# UNITED STATES PATENT AND TRADEMARK OFFICE

10/534,479

<b>Office Action Summary</b>	<b>Application No.</b> 10/534,479	<b>Applicant(s)</b> SUCH ET AL.	
	<b>Examiner</b> MICHAEL KAHRELIN	<b>Art Unit</b> 3762

## DETAILED ACTION

FIG. 2

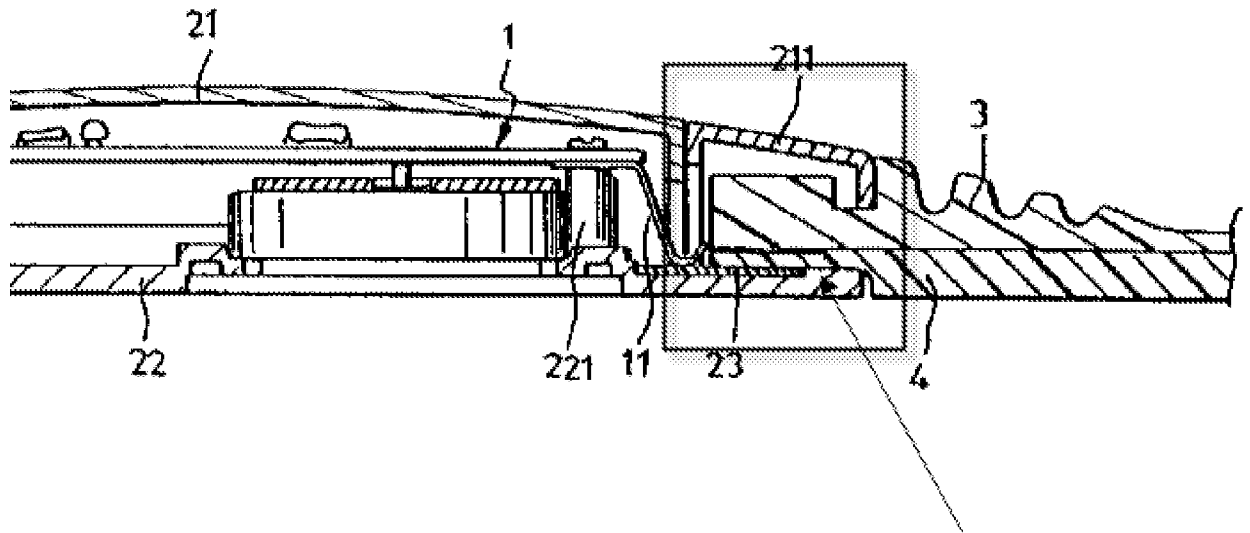
4. Claims 1-3 and 6-10 are rejected under 35 U.S.C. 102(b) as being anticipated by Chen (US 5,778,880, hereinafter "Chen").
5. In regards to claim 1, Chen discloses a wearable system comprising an electronic device (1 and 4) mounted on a carrier (3 and 22), wherein the electronic device comprises electrodes (4 and 23 on the left and right side of the device), a portion of which extend through the carrier for facilitating the fixation of the electrodes on the carrier (see figure below) and shaped to fit on the carrier's receiving portion (see underside of "3").

Electrode extending through  
(at least a portion of) the  
carrier

**16.** Applicant's arguments with respect to claims 1-11 have been considered but are moot in view of the new ground(s) of rejection, necessitated by amendment. In regards to claim 1, the Examiner maintains the rejection in view of Chen because the claim language does not require that a portion of the electrode extends completely from one side of the carrier to the other, but only "through." The examiner considers the limitation "through" to only require passage through a portion of the carrier.
